Project: DOUGLAS STATION
LSMO
Issue Date: August 11, 2023

COVER SHEET
Construction Plans for:
Douglas Station Commercial Park
Lee's Summit, Jackson County, Missouri

REVISIONS
REV. 3/7/2024

STORM SEWER GENERAL LAYOUT

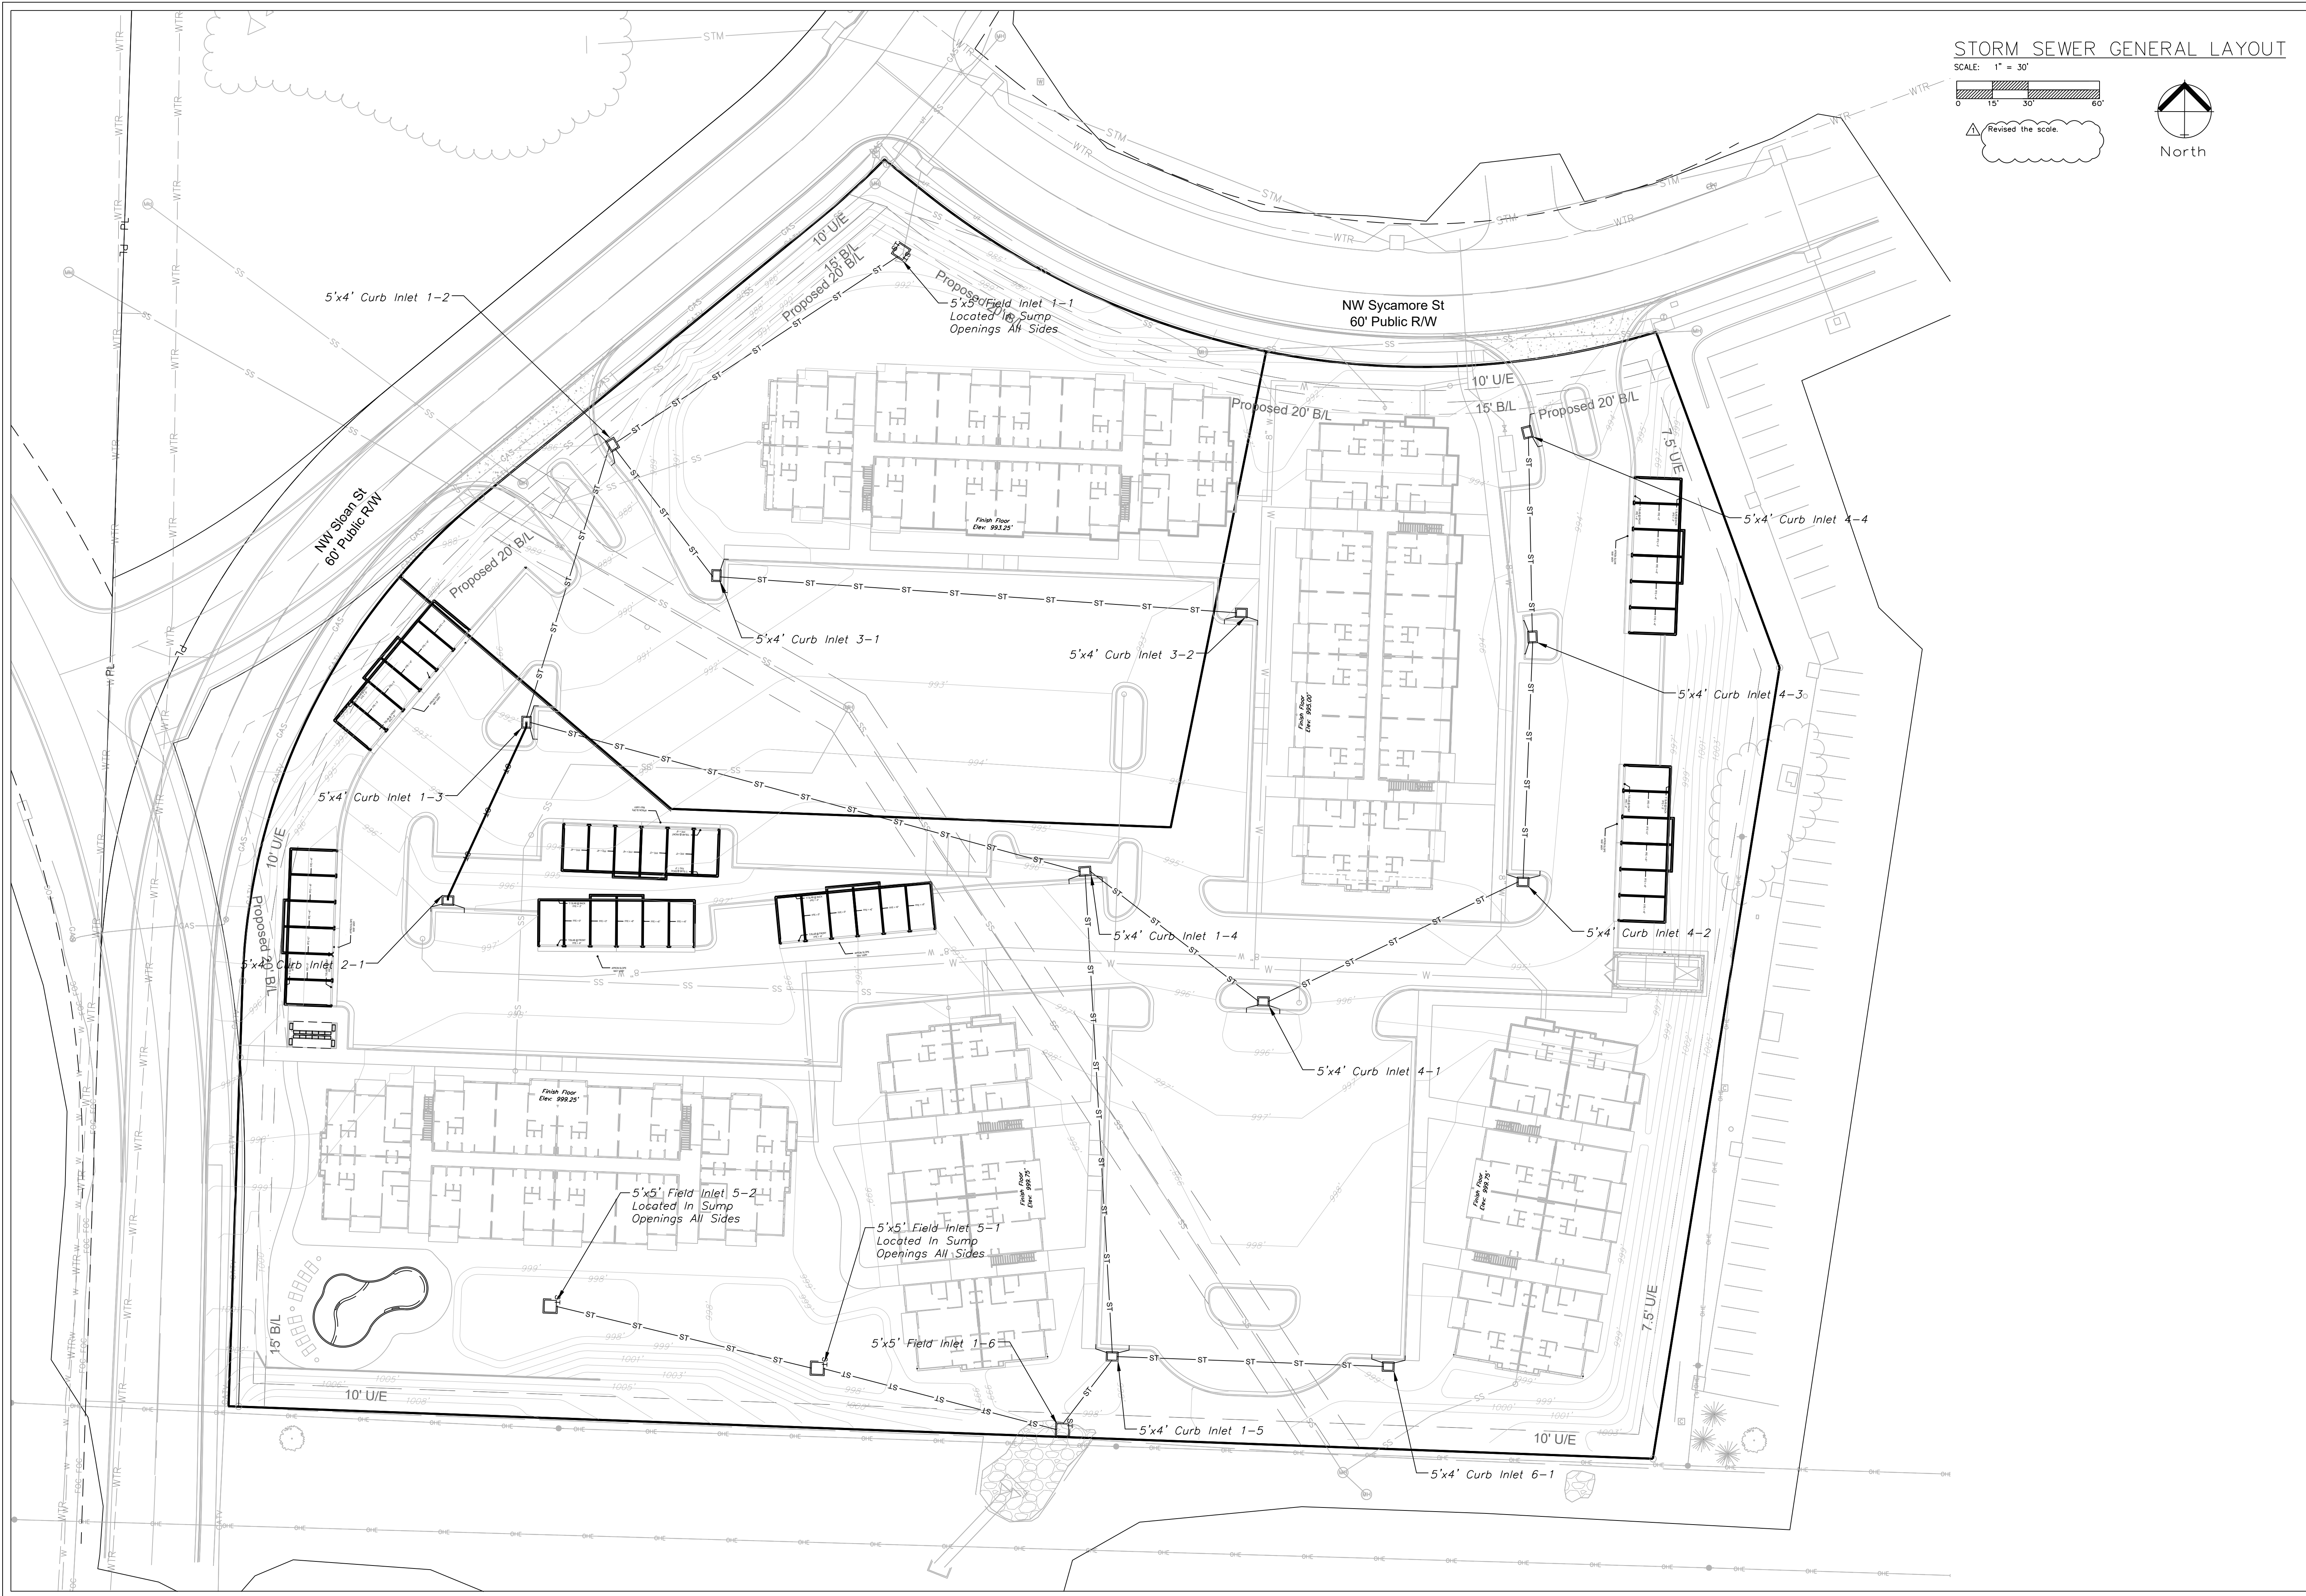
Revised the scale.

SCALE: 1" = 30'

STORM SEWER PLAN AND PROFILE

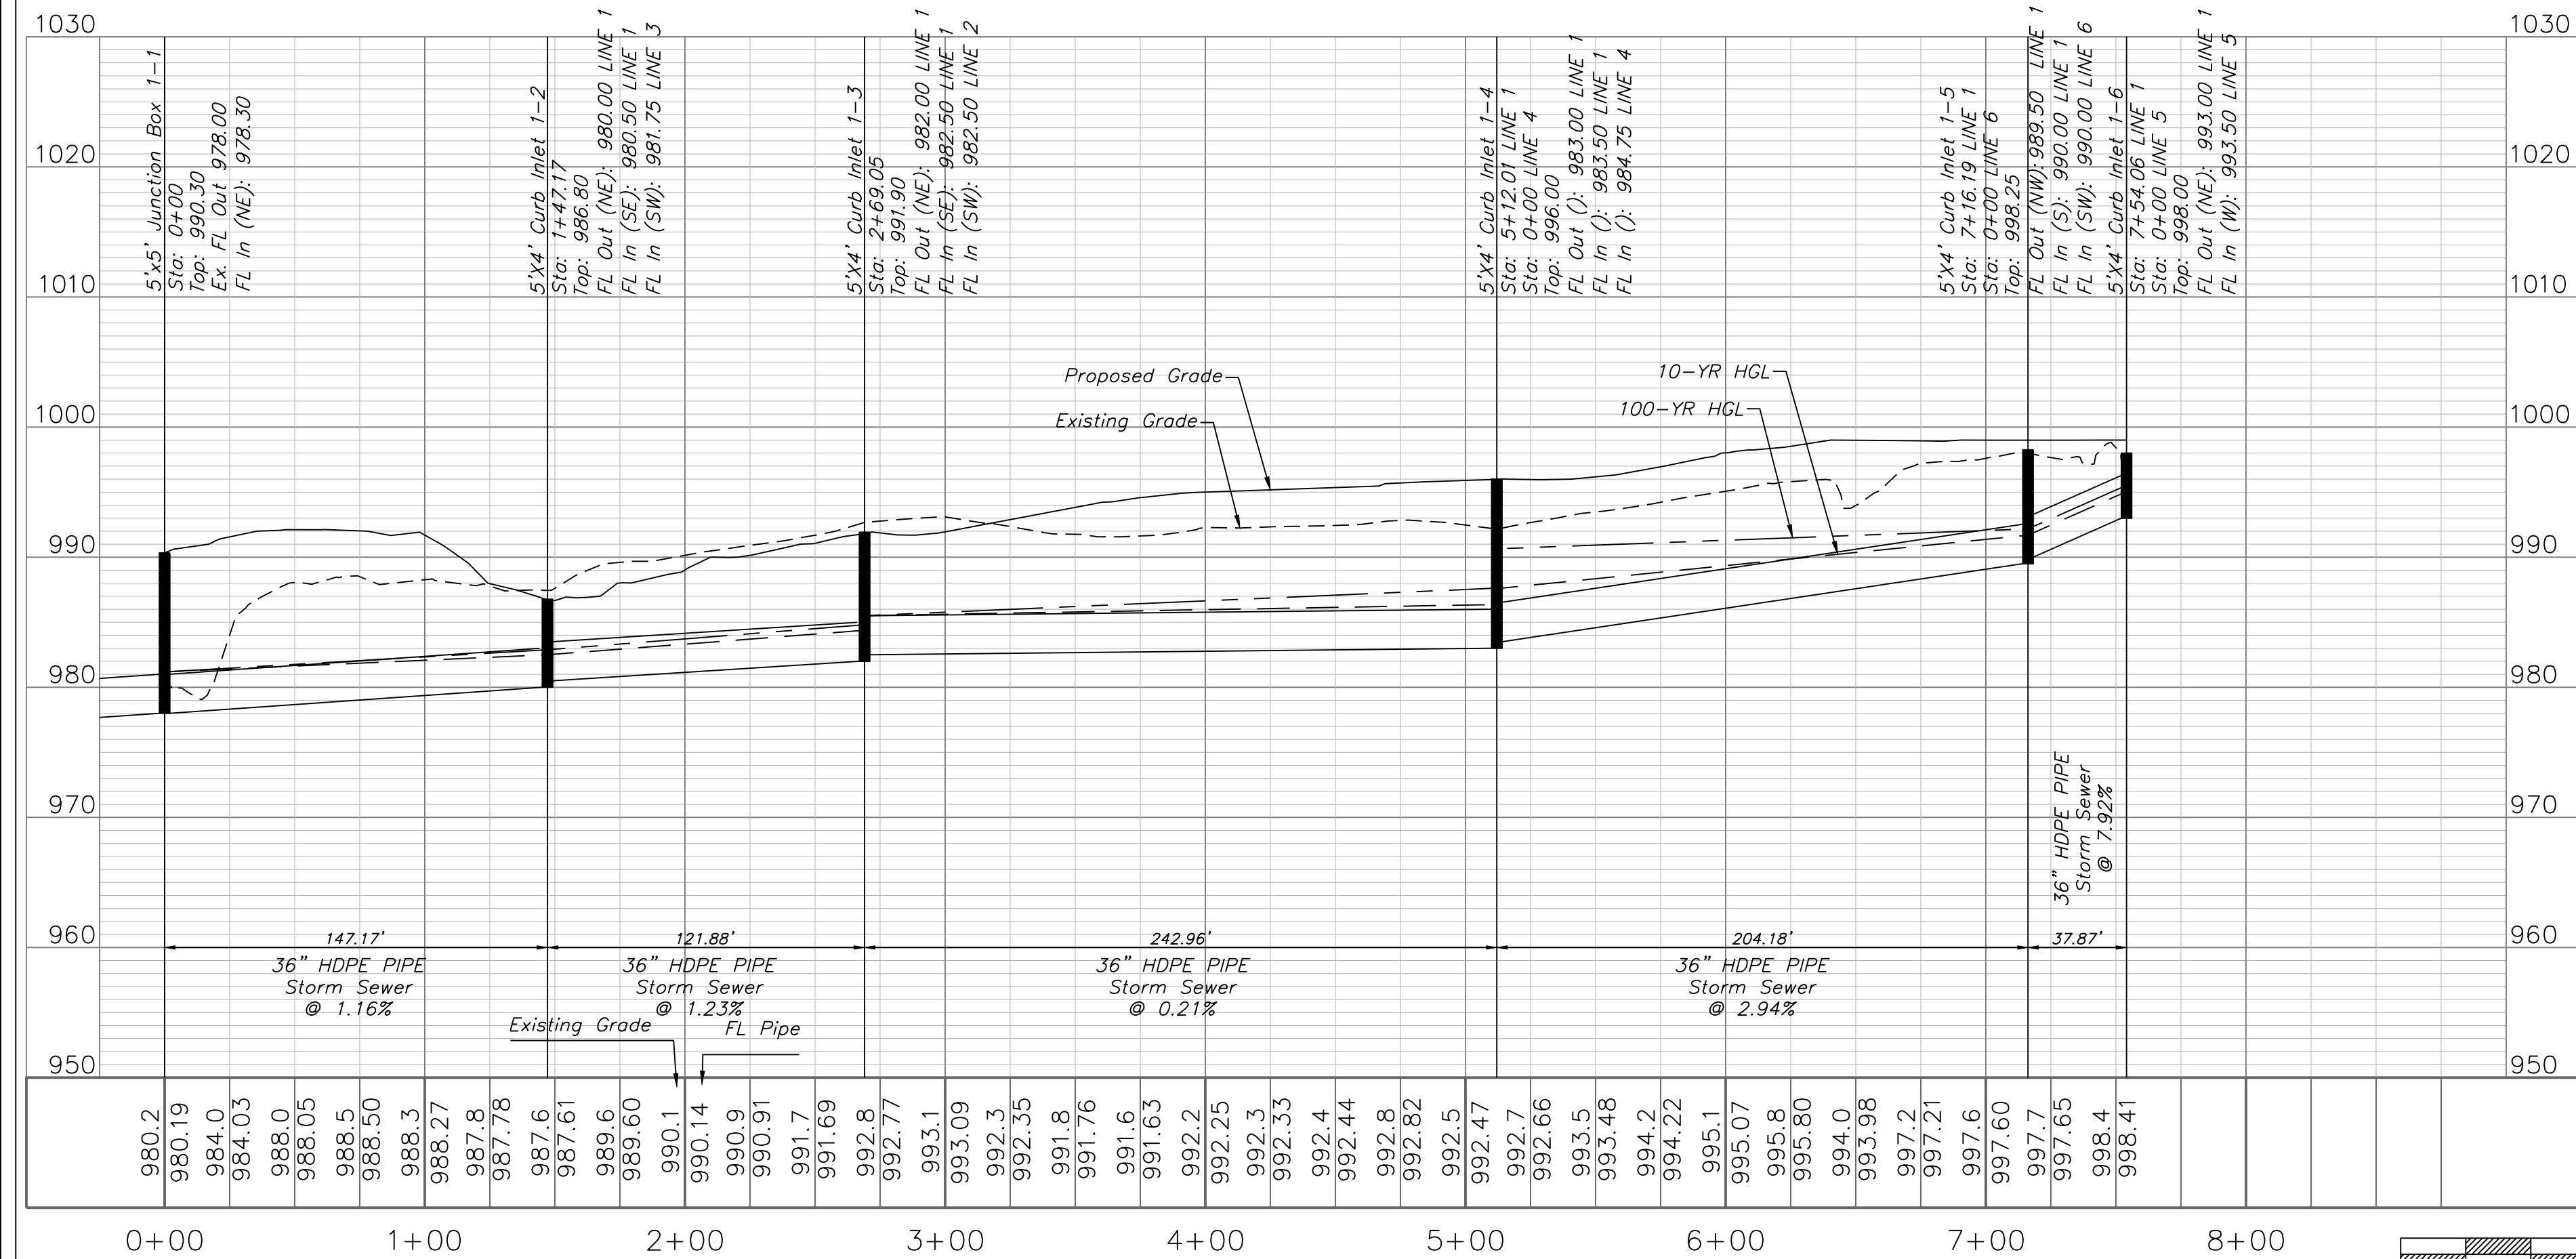
REVISED SCALE.

SCALE: 1" = 50'

WATER LINE 1

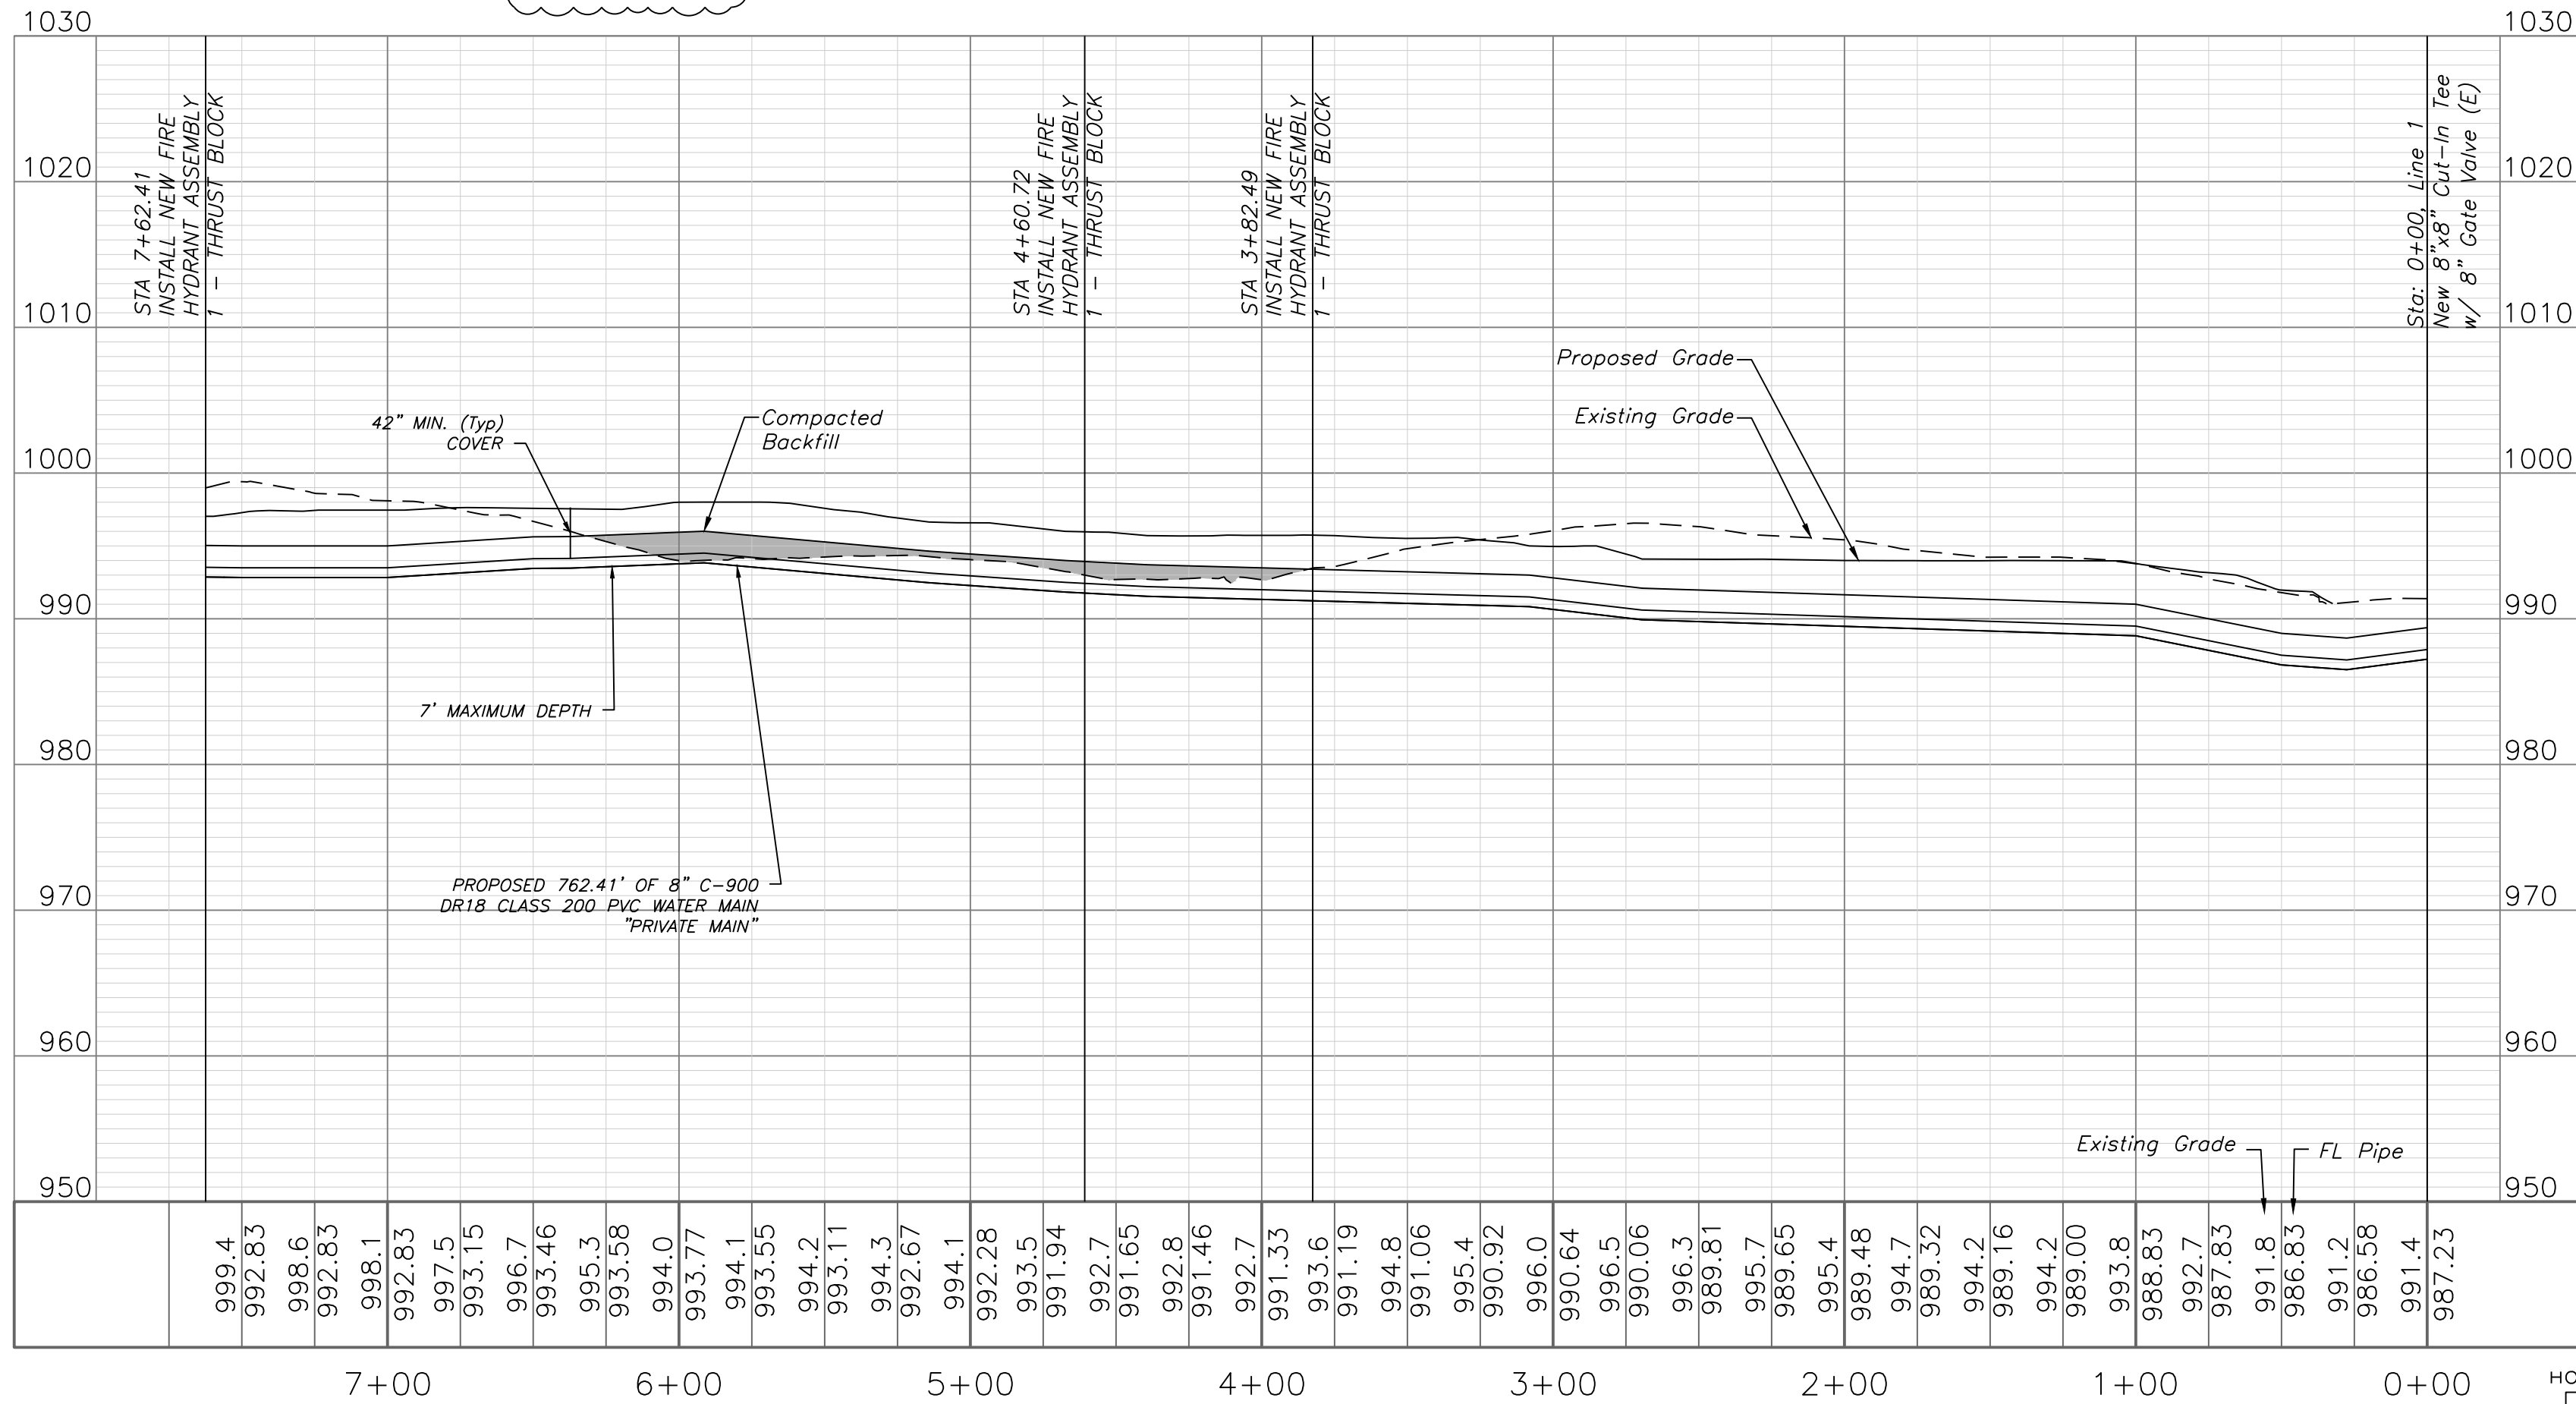
▲ ADDED C900 DR18 Class 200 LABEL.
